**EXPERT-PANEL REVIEW OF CNWRA  
COUPLED THERMAL-MECHANICAL-HYDROLOGICAL  
PROCESSES RESEARCH PROJECT**

**Nuclear Regulatory Commission  
Contract NRC-02-93-005**

**Center for Nuclear Waste Regulatory Analyses  
San Antonio, Texas**

**September 1995**

Figure 1: Relative behavior for TH migration from a heated drift or repository with transport by (a) pressure drive in low permeability materials, (b) buoyancy effects in high relative permeability materials, and (c) buoyant escape from the heated region with return flow by capillary wicking.

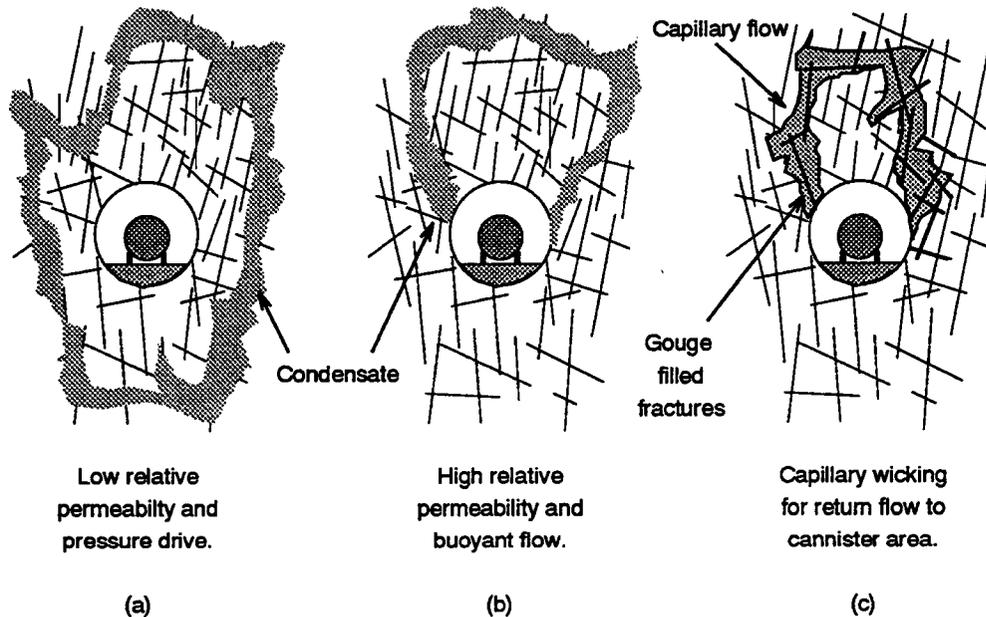
The raw processes governing vapor transport behavior appear well documented (Manteufel et al., 1992) although the constraints on behavior in heterogeneous fractured geologic media seem less certain. This is considered a crucial KTU. A modeling study to evaluate the sensitivity of the resulting behavior to variability in the geological environment is, correspondingly, suggested. The evaluation might include evaluation of behavior for geological environments conceptualized in Figure 1 and characterized by three alternate configurations, namely:

important in evaluating the transport and sorptive characteristics of fractures and fracture zones, and defining the potential for capillary recirculation around the waste packages (see Figure 1).
